**Project #3030684-LU**

Correction Notice #2

Review Type : Land Use

Project Address : 4311 7TH AVE NE SEATTLE, WA 98105

# Exhibit -1

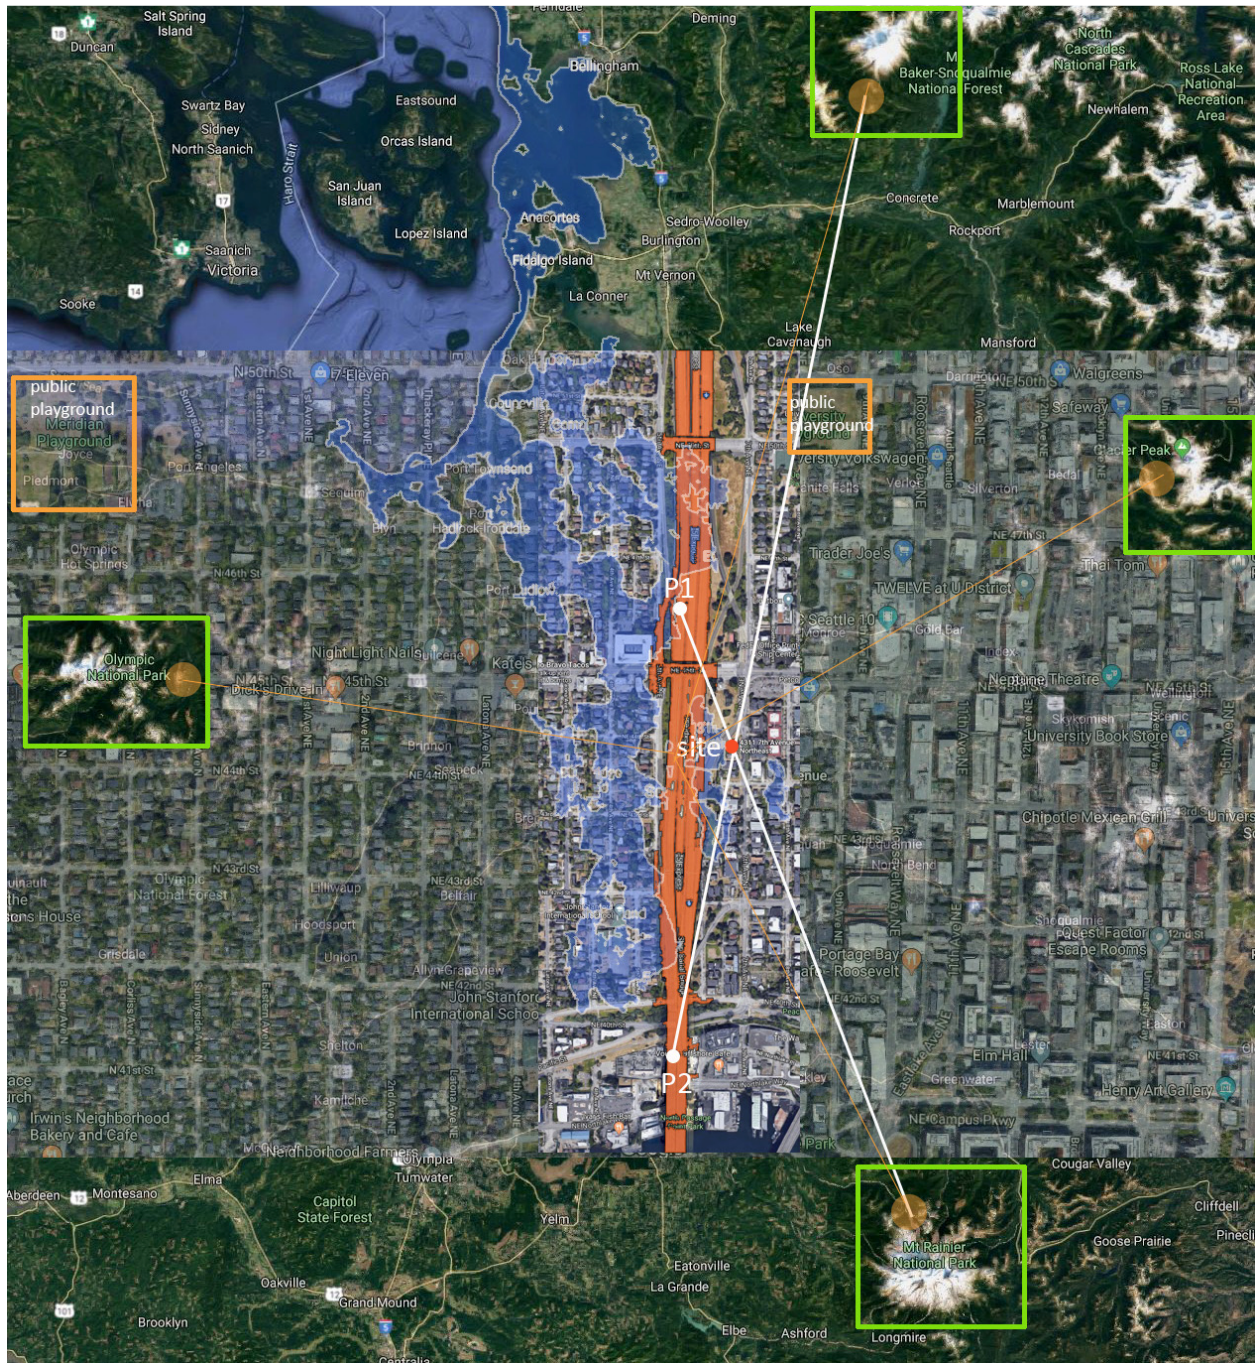
*Views. SMC 25.05.675.P.2 1% Northbound and 1% Southbound are scenic view corridors (potential mitigation listed in SMC25.05.675.P.2.d). Please demonstrate how the project is designed to protect public views this right of way.*

See Exhibit 1 - View study.

View corridor study of major landmarks along I-5.
